REPORTS OF
CONSULTING BOARD
ON
LAKE HODGES DAM
SAN DIEGO COUNTY, CALIFORNIA

Report to State Engineer

on Lake Hodges Dam

March 11, 1929.

Maximum Section of Dam.
PLATE I

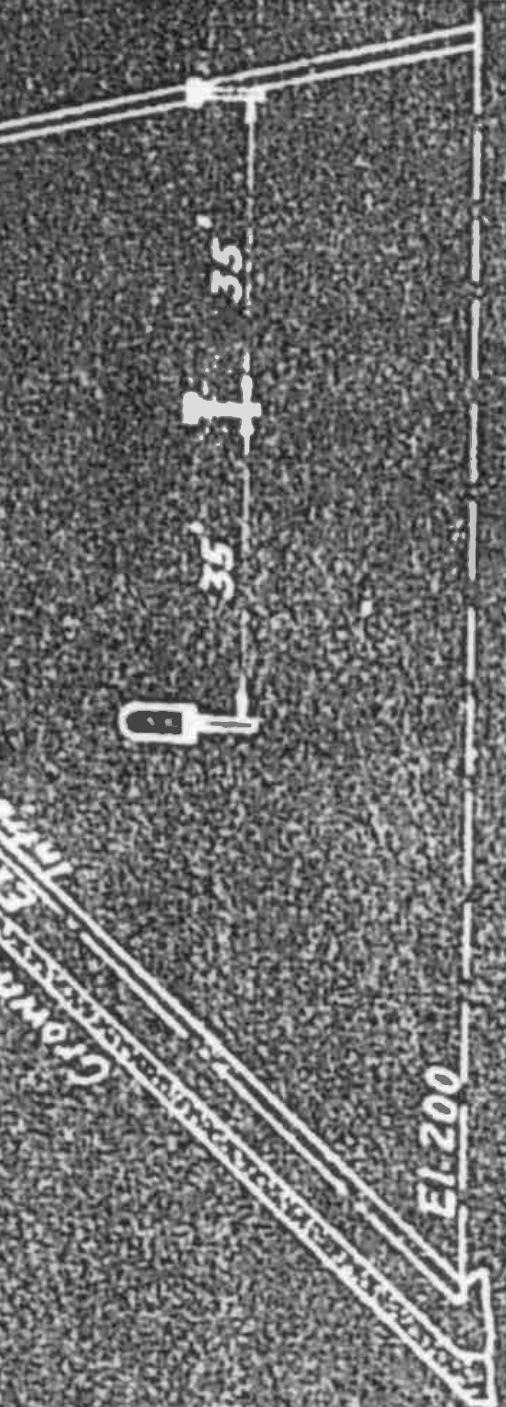
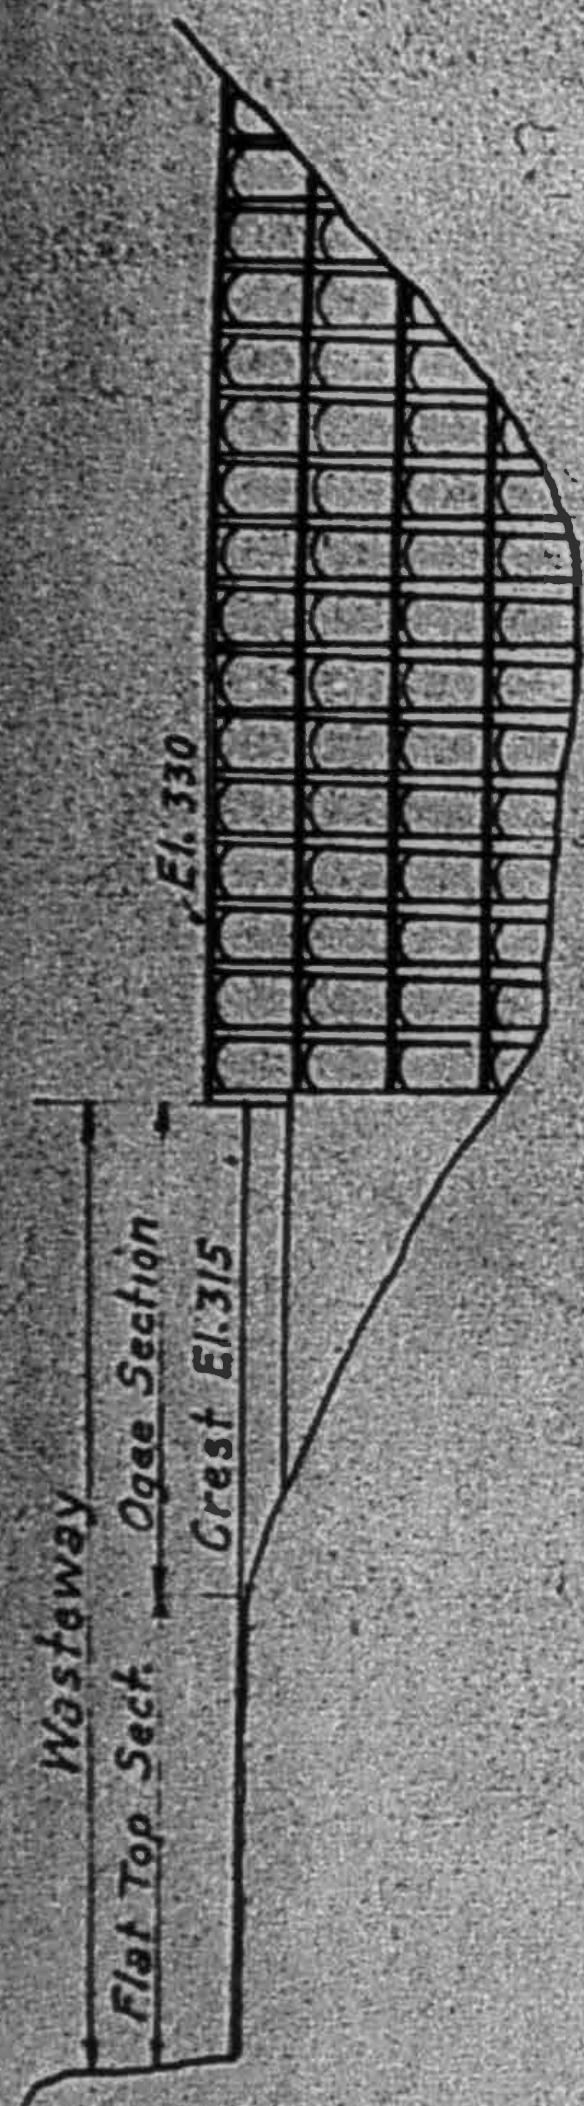
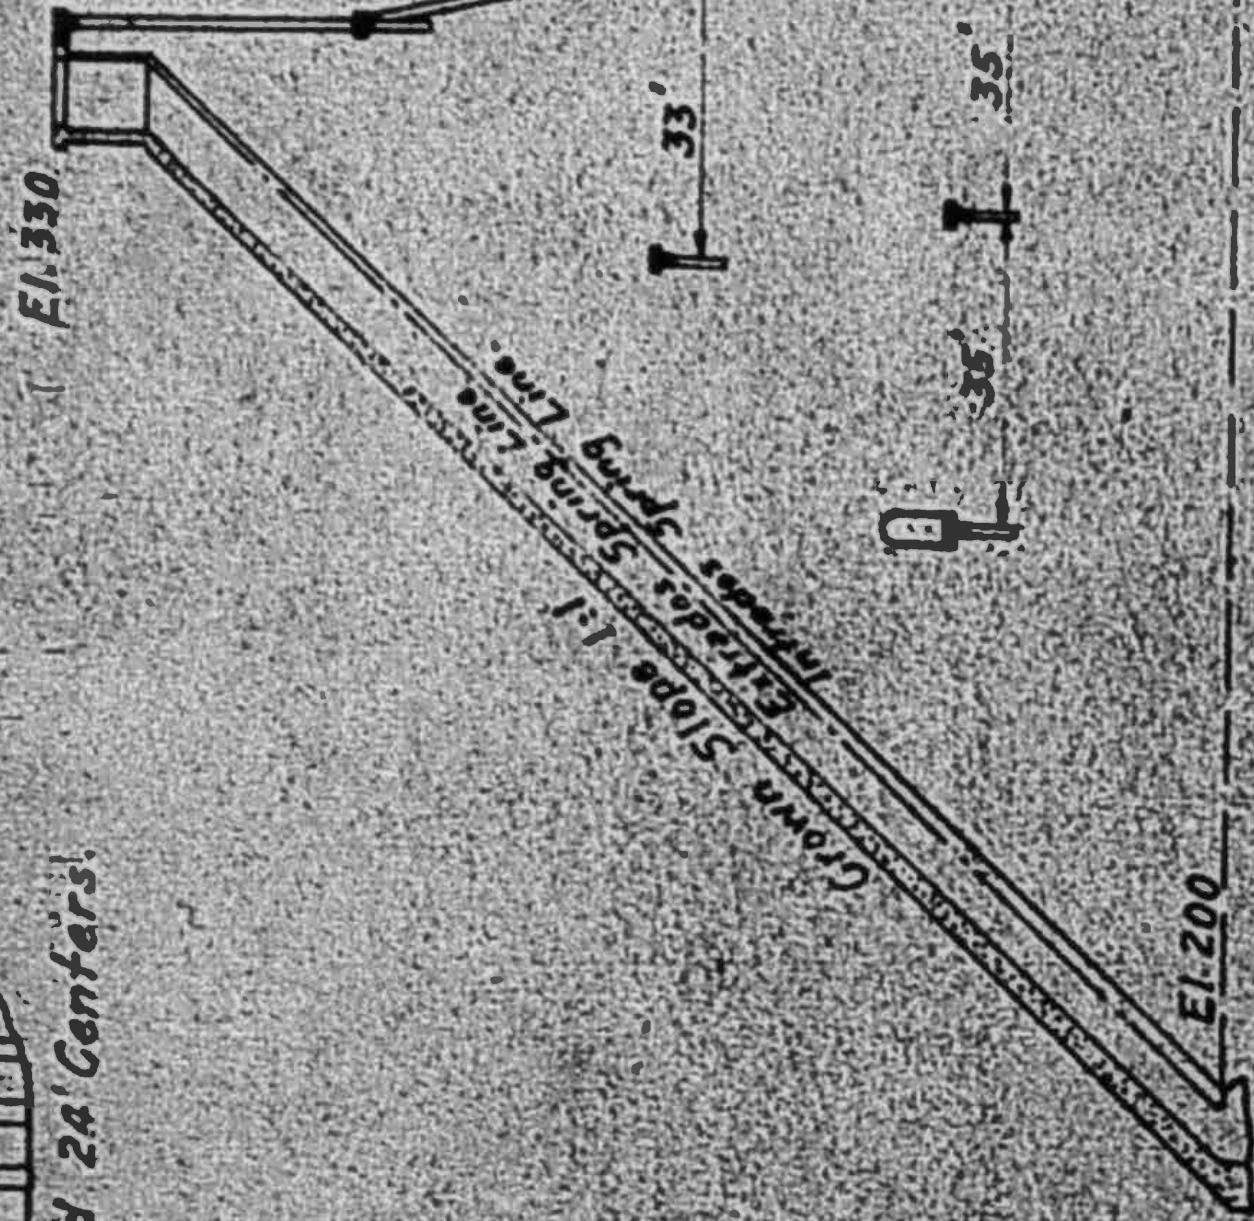
Lake Hodges Dam is a concrete multiple arch dam of the Eastwood type. It is located on the San Dieguito River about thirty miles from San Diego. The dam consists of the main non-overflow portion, with a crest length of 390 feet, the ogee rollway portion 175 feet in length, and the broad crest spillway extension cut in the side hill 185 feet in length. The maximum height of the dam is about 130 feet above the streambed. The top of the dam is 15 feet above the crest of the spillway. The buttresses are unreinforced, except where arches, strut beams and foot walks are tied in. They are spaced 24 feet on centers. Their thickness is 18 inches for the top 47 feet, and increases to 4 feet at the base for the highest buttress. The northerly seven buttresses are covered with a reinforced concrete deck roll-way forming the ogee portion of the spillway. Reinforced concrete struts placed at intervals of about 35 feet both vertically and horizontally give the buttresses some lateral bracing. The arches are reinforced and have a minimum thickness of 12 inches for the first 50 feet below the crest. Below the 50 foot point the thickness increases to 2 feet and 7-1/2 inches at the bottom of the dam. The slope of the crown of the arches is 45°.

Sketch showing position of crack in Buttress No 6
The position of crack is typical of that in all
butresses though this is longer than cracks
in other buttresses.
Note:- Crack does not enter either the arch
ring or the base of Buttress.

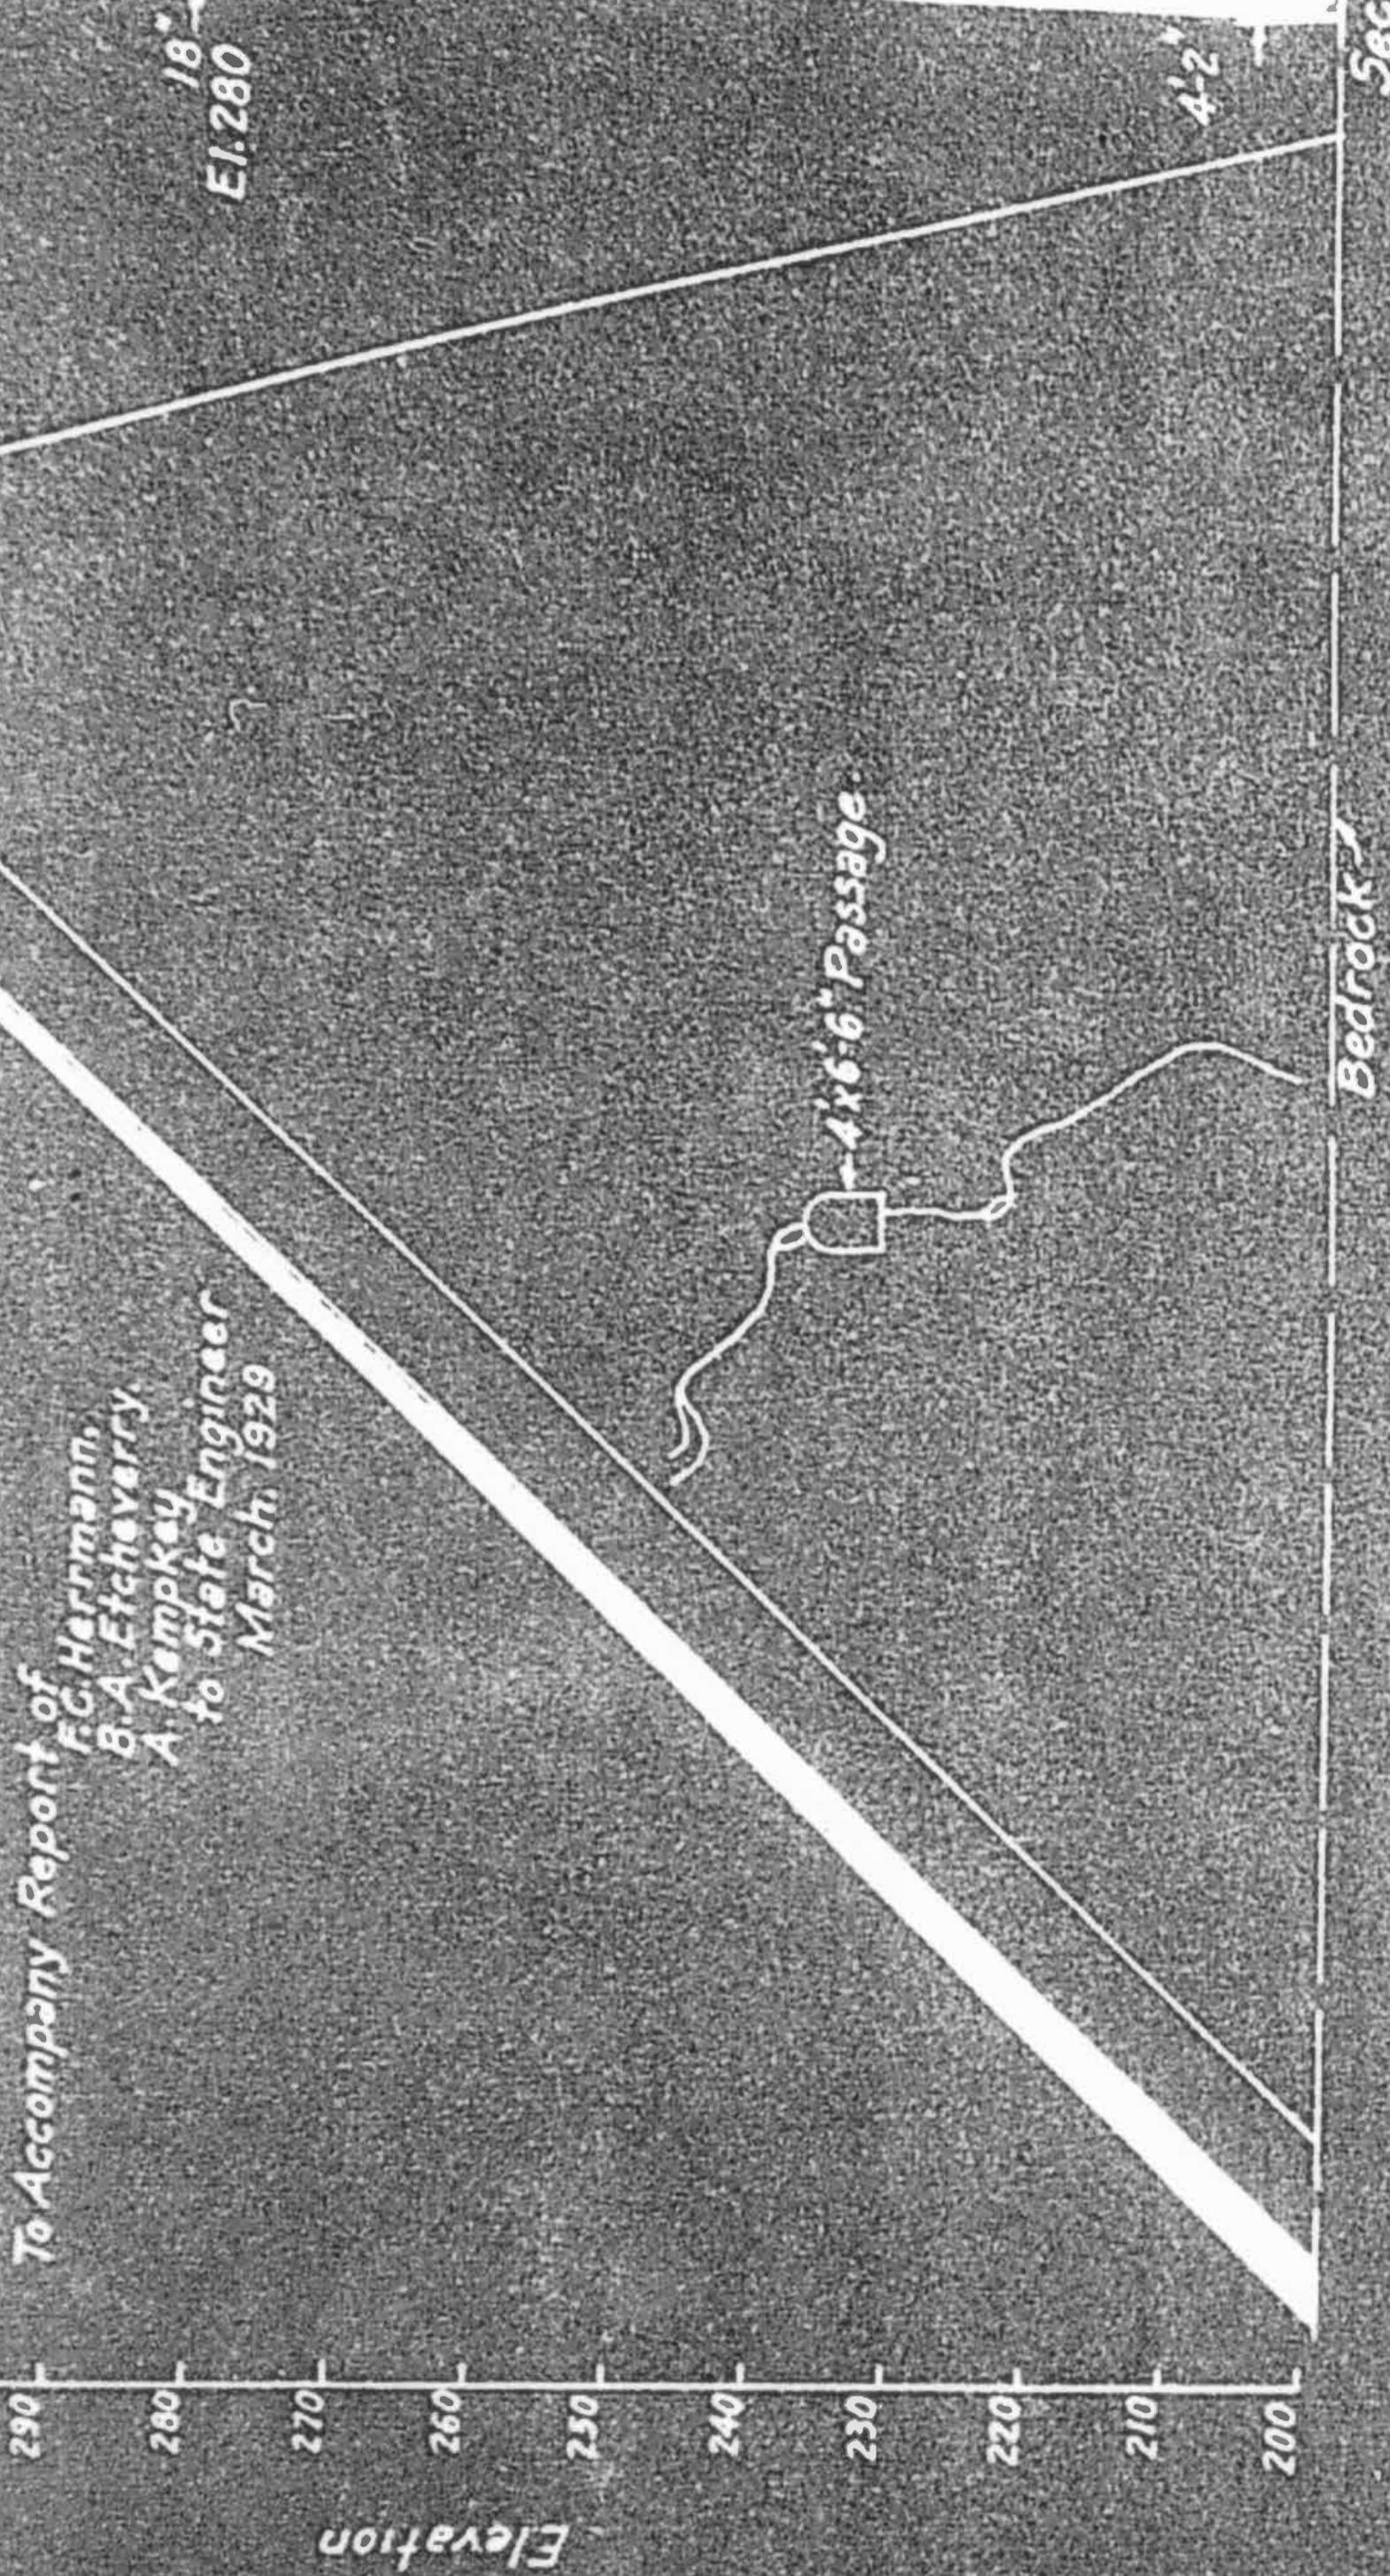
The cracks have been mapped and are shown on diagrams included in Mr. Brahtz's report. A typical crack is shown on Plate 2 of our report. The cracks generally extend upward from the roof of the gallery archway toward the arch rings in a direction about at right angles to them, and downward from the floor of the gallery foot walk about vertically toward the foundation. The cracks have a maximum width at the gallery. They gradually decrease in width in either direction from the gallery, and end before reaching the arch rings at the upper end and the foundation at the lower end, with the exception of one crack the upper end of which extends for a short distance into the arch ring.

We find that the variations in water pressures on the dam have no relation to the variations in the width of the cracks, and the study of stresses in the buttresses shows no loading stresses which could have produced the cracks. We conclude that the cracks themselves as well as the variations in their widths are due to the expansion and contraction resulting from changes in temperature and moisture conditions together with shrinkage occurring during the period of hardening of the concrete. The permanent increase in width is due to the long time continued shrinkage of concrete in the process of hardening, and the water pressure transmitted to the portion of the buttress lying above the crack as this pressure favors the widening of the crack during the period of contraction in the concrete and resists narrowing of the crack during the subsequent period of expansion of the concrete. In addition closure of the cracks may be mechanically restricted by the lodgment of dust or small particles of foreign matter.

The presence of the cracks in the buttresses does not affect their stability. Should these cracks in the future be so enlarged as to extend upward and completely through the arch rings and downward to the foundations so as to completely separate the upper portion from the lower portion of the dam, we would have the condition assumed by Mr. Brahtz in his very thorough analysis.
